**STAFF REPORT
WEST ALLIS PLAN COMMISSION
Wednesday, October 25, 2023
6:00 PM**

5. Site, Landscaping, and Architectural Design Review for Pan-Asia Supermarket, a proposed General Retail use, at 6900 W. Greenfield Ave. (Tax Key No. 439-0001-007)

The numbered items below are staff comments shared with the applicant upon review of the original plan submittal. The applicant's design team has revised plans to accommodate staff's recommendations. A comparison of the initial and most recent plan submittals is provided for Plan Commission review. After reviewing the revised plans, items 1-3 are satisfied, and items 4-5 were offered to applicant for consideration but not required.

EXTERIOR ELEVATIONS
A4.00

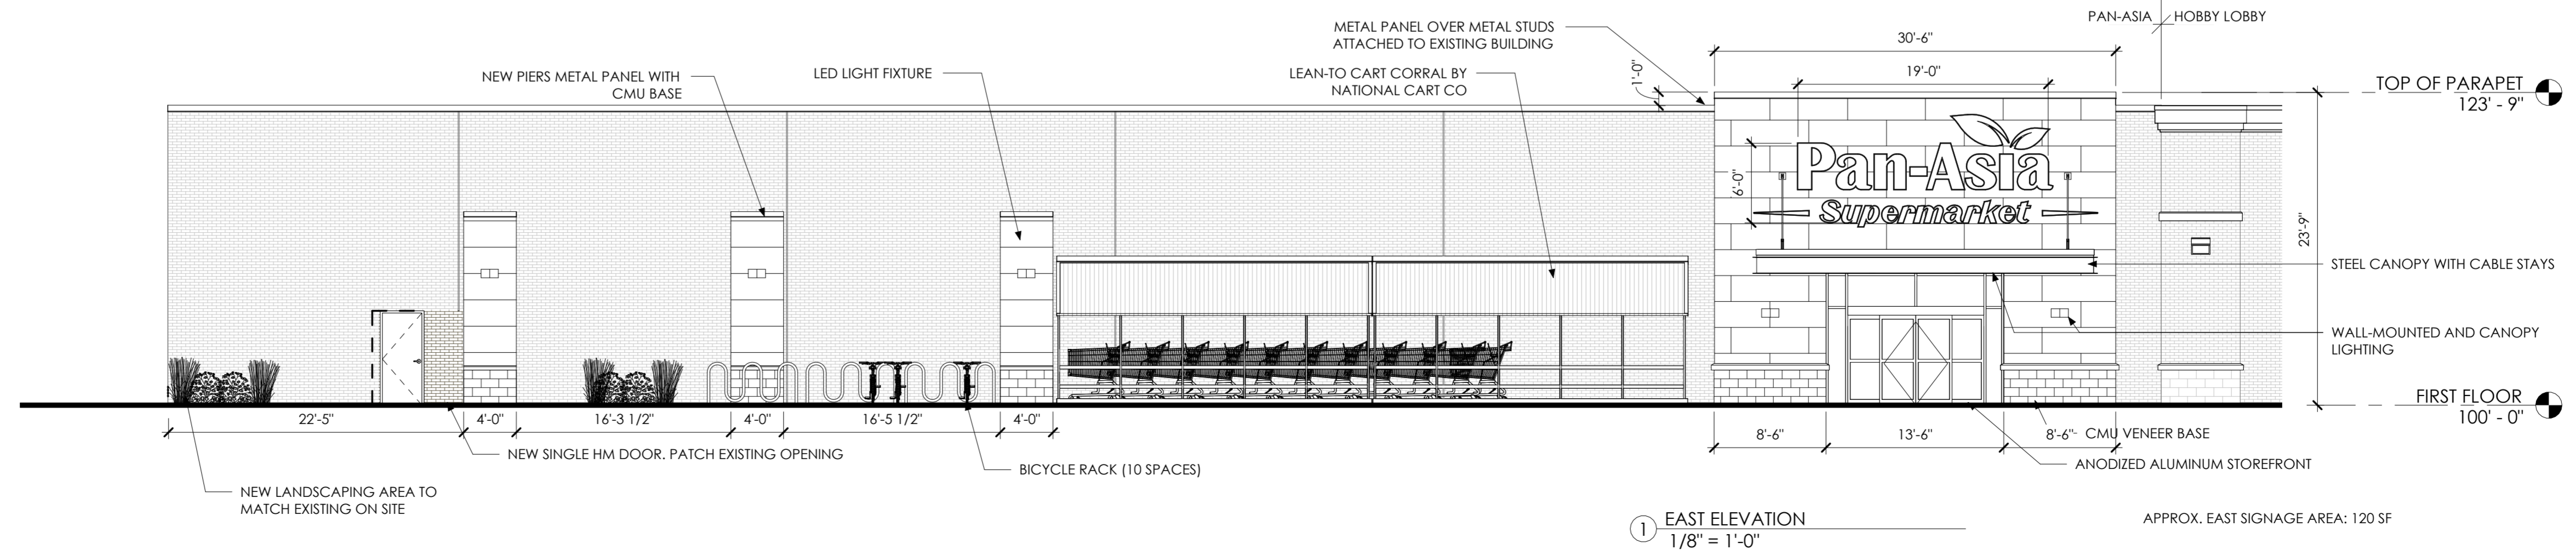
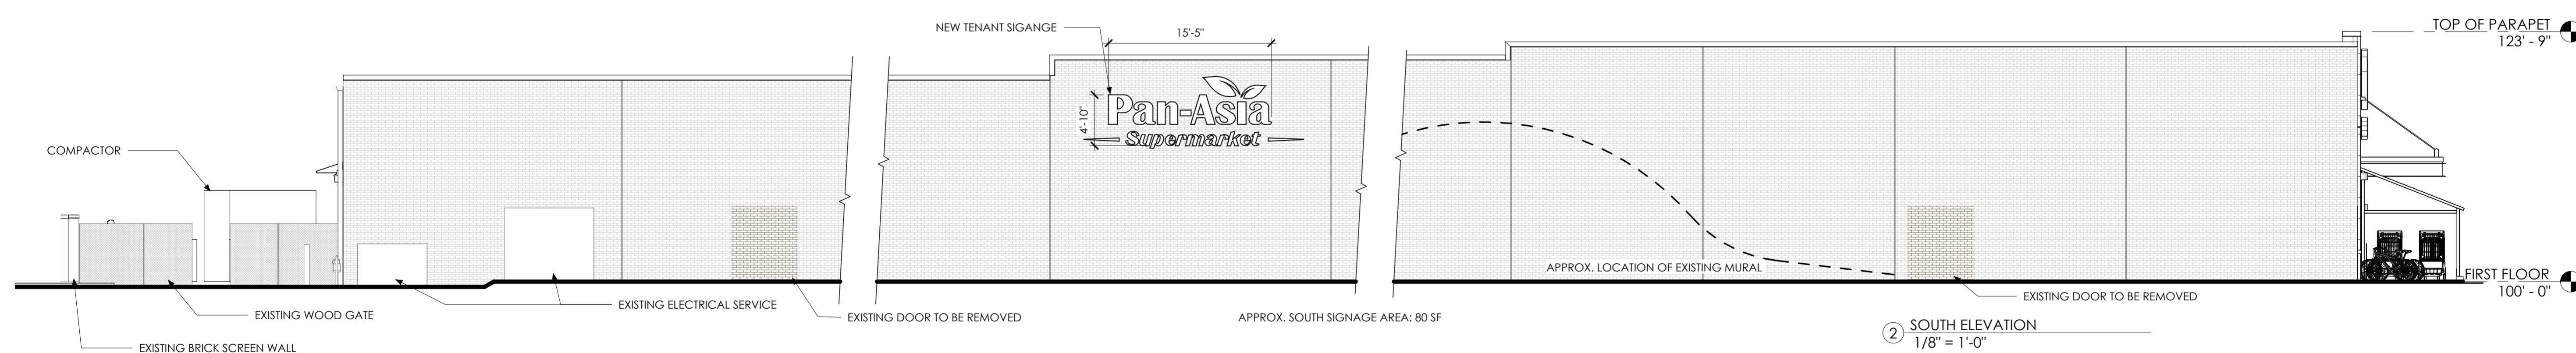
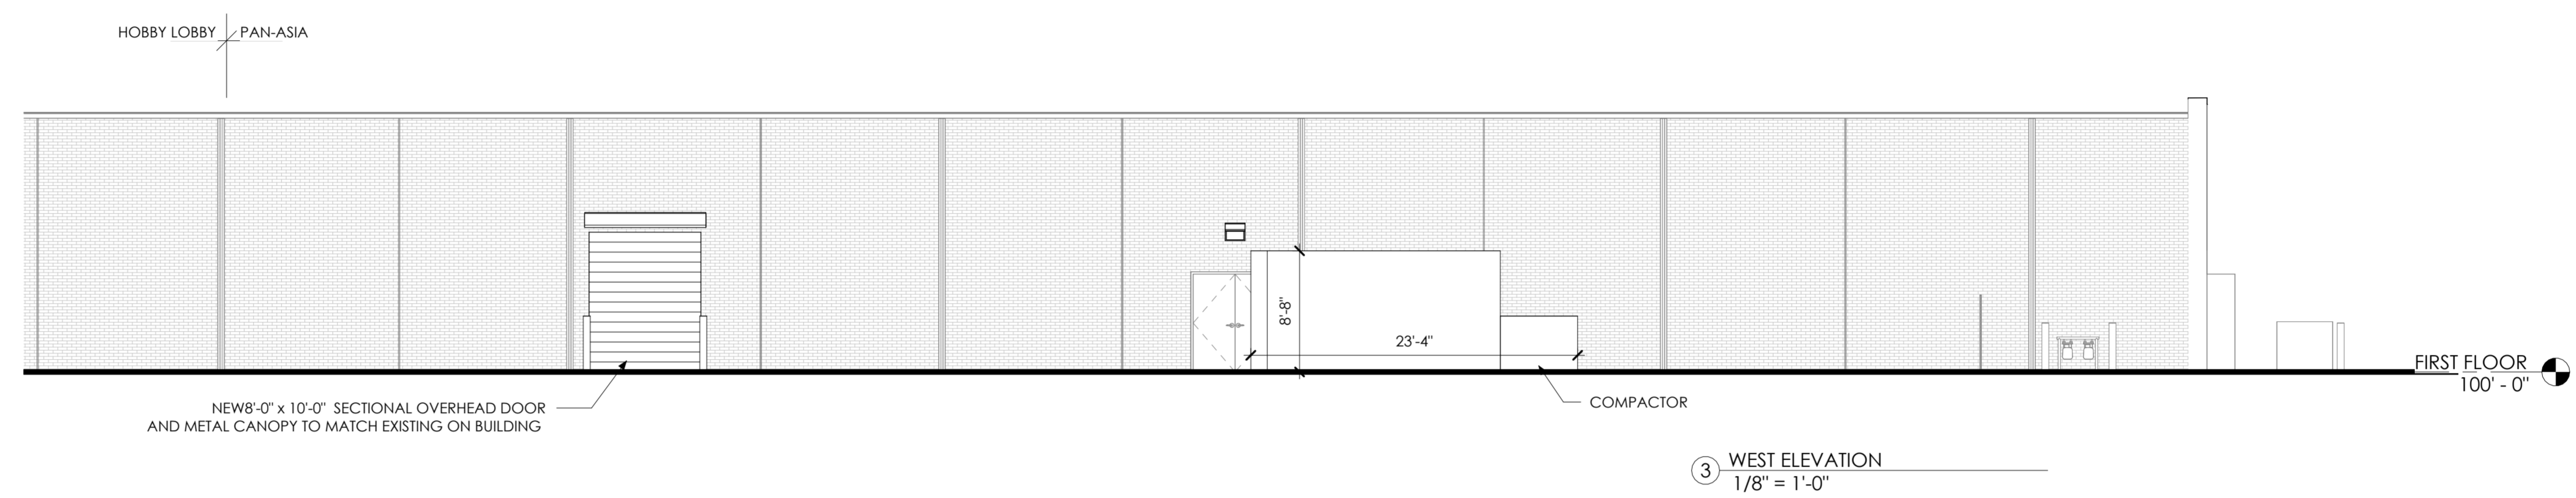
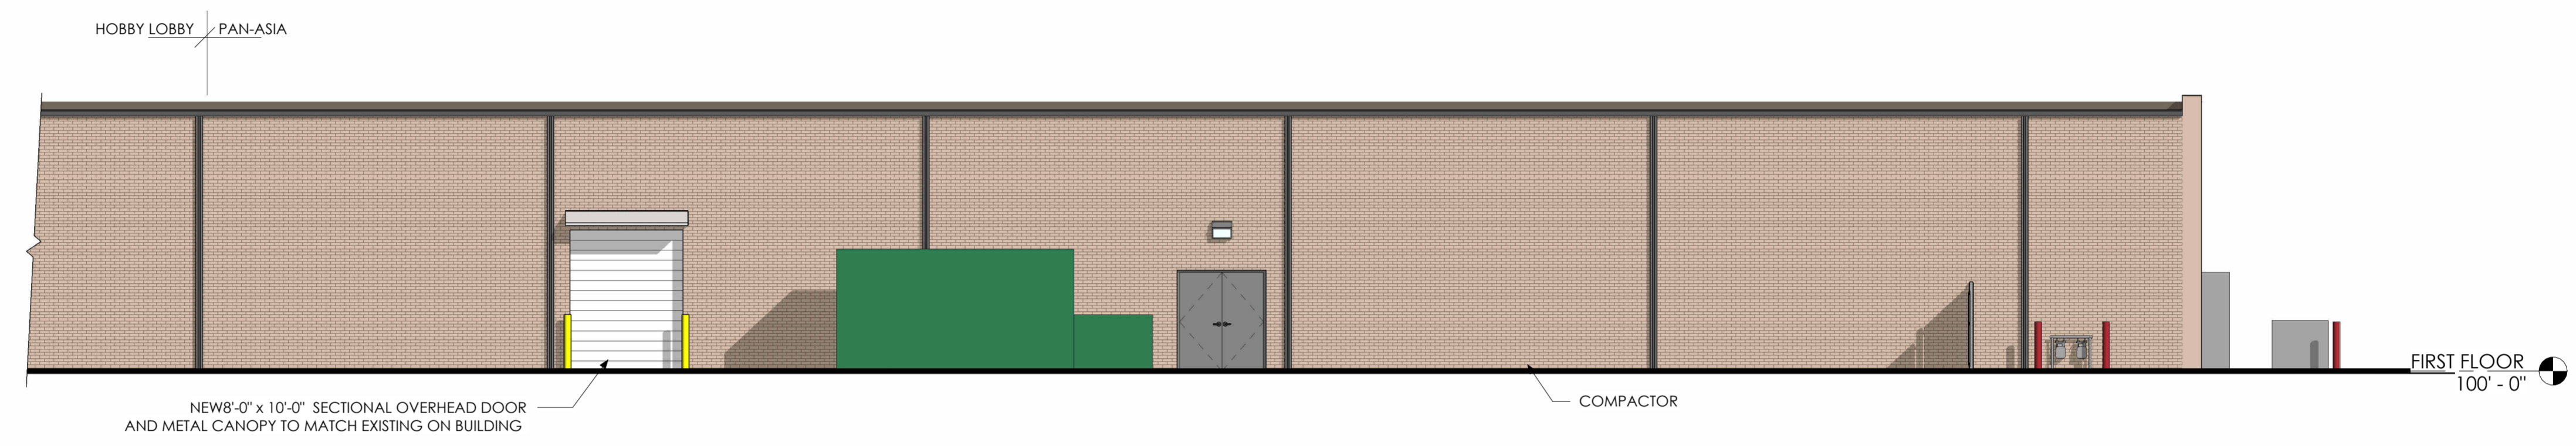
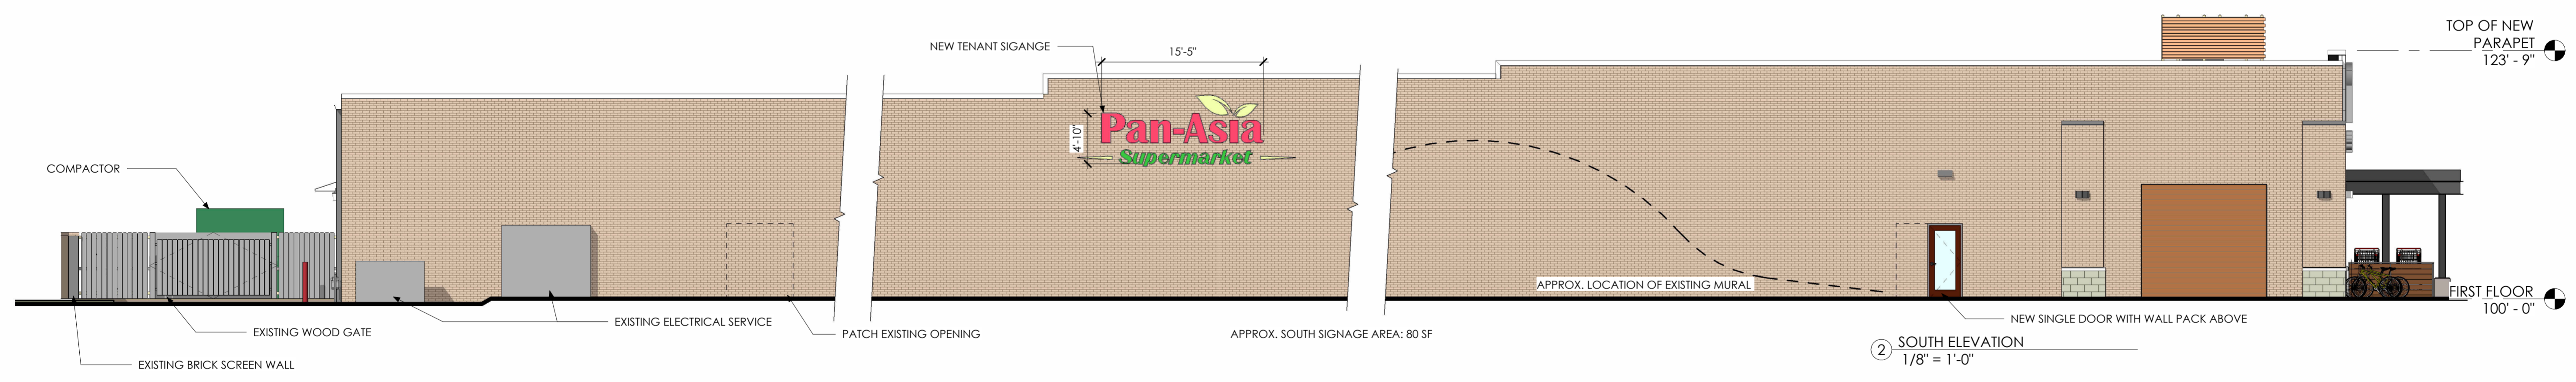
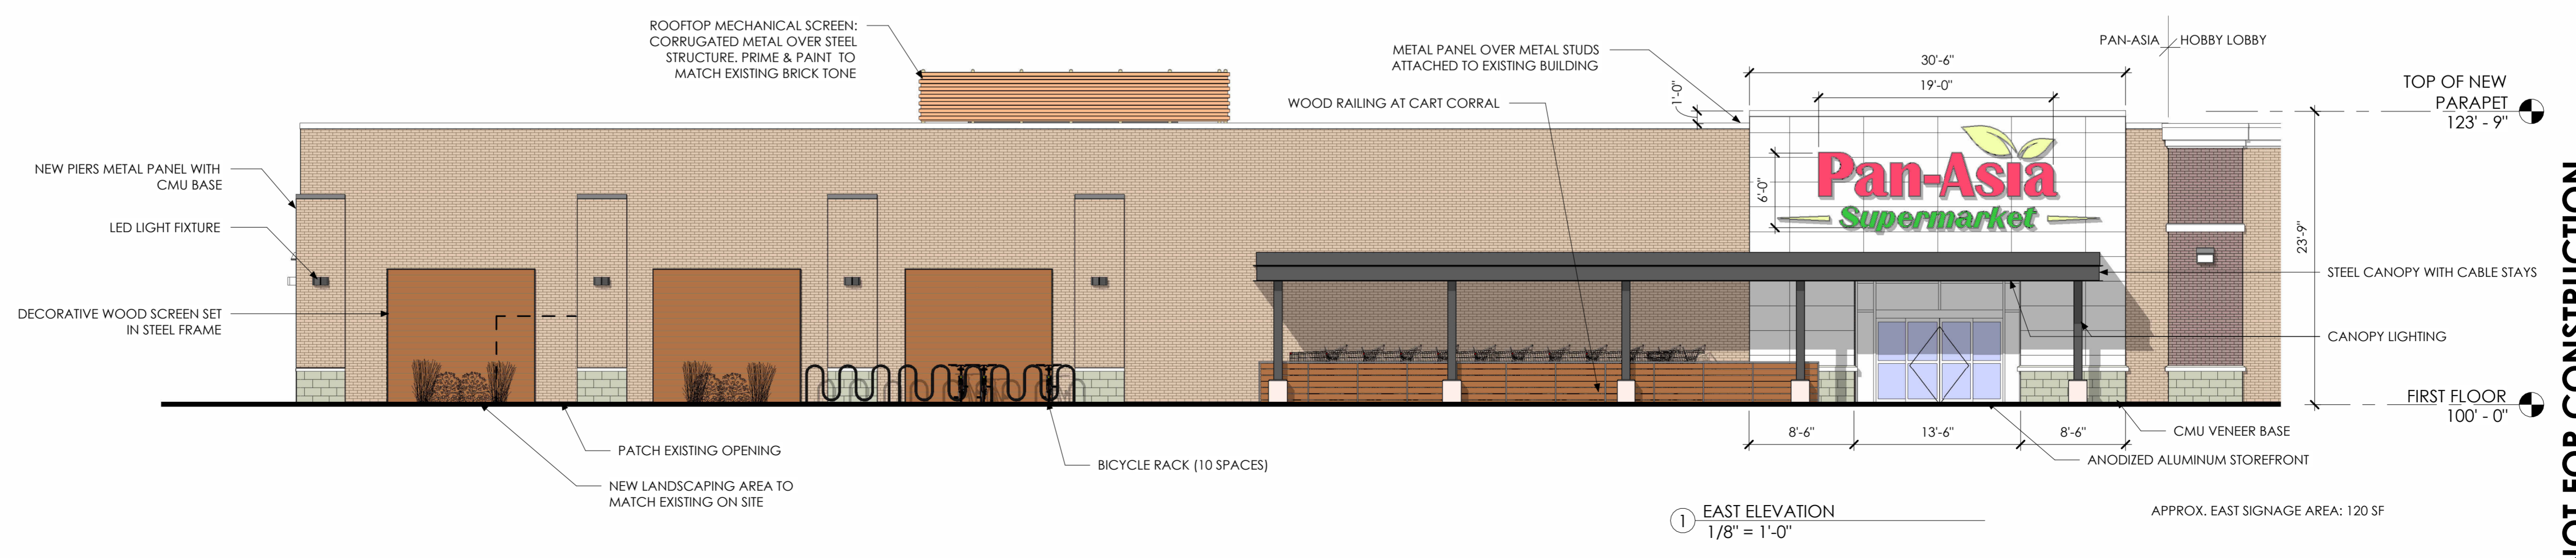
1. The exterior cart corral (by national cart co) is located centrally on east side of the building façade and corral's design is basic and bears no design consistency with the building... There is a Pan-

Asia store in [Tulsa, OK on E 71 St](#) that offers some ideas that may be incorporated into the West Allis site (brick screen wall and framing/mullions). Also, for similar reasons, as an alternative to the hipped roof over the corral, adding or extending the proposed flat bracketed store-entrance canopy would balance and help create a more consistent look.

2. There is a large pilaster just north of the Pan-Asia entry (at south end of Hobby Lobby space). Thoughts on adding a similar proportioned feature on SE corner of building except with Pan-Asia cladding.
3. General questions on where and how visible any exterior HVAC rooftop units (existing/new) and considerations on how kitchen area will be vented (wall or rooftop). Is there a plan sheet that will show these features?
4. Placement of the kitchen on the east wall versus placing some seating and windows on east wall. If flipped/re-orientated then windows could be incorporated into the east wall design (benefits like natural light, storefront attraction, visibility).
5. The new storefront entry into the building looks great. Curious on the location of the entry toward the north side of the tenant space? Floor planning customer flow a likely reason, but just asking.

1. Submit revised site, landscaping, and architectural plans to the Planning & Zoning office to show the following: a) a detail of the proposed exterior wood screens in steel frames on the facade; b) rooftop plan and screening material details; (c) cart corral details; (d) curb extension added along storefront pedestrian walkway.
2. A driveway permit being applied for with City Engineering Department for work within the City Right-of-Way.
3. Signage plans being submitted for sign permit review.
